TO: All Bourgault Dealers
ATTN: Service Manager, Parts Manager, Sales Manager
SUBJECT: XTC Depth Adjustment Upgrade

SPECIAL PRICING UPGRADE: (Failure Code 2.17)
Effective serial number range: XTC units prior to model year 2017

CURRENT XTC DEPTH ADJUSTMENT ASSEMBLY

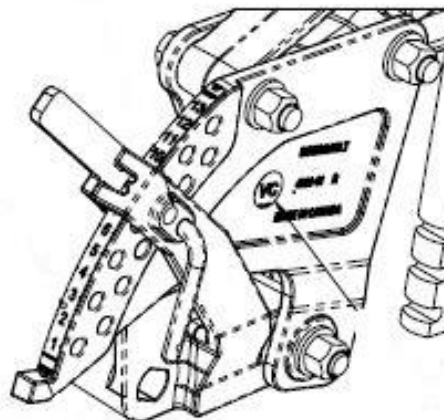
The current XTC drill depth adjustment mechanism consists of a spring loaded depth adjustment handle and meshing teeth to provide 1/4" depth increments. This design has presented manufacturing challenges as well it requires customer maintenance to ensure the depth adjustment handle pivot bolt is kept at the correct tension to avoid "pre-mature" wear of the meshing teeth.

With model year 2017 all XTC units will be built with a new style of depth adjustment. The meshing teeth will be replaced by a cast assembly with holes placed at specific intervals to provide 1/4" depth adjustment and the spring loaded depth adjustment handle will be replaced with a depth adjustment pin. Testing has shown this new design, with significantly more bearing area, will provide many years of use without any significant wear.
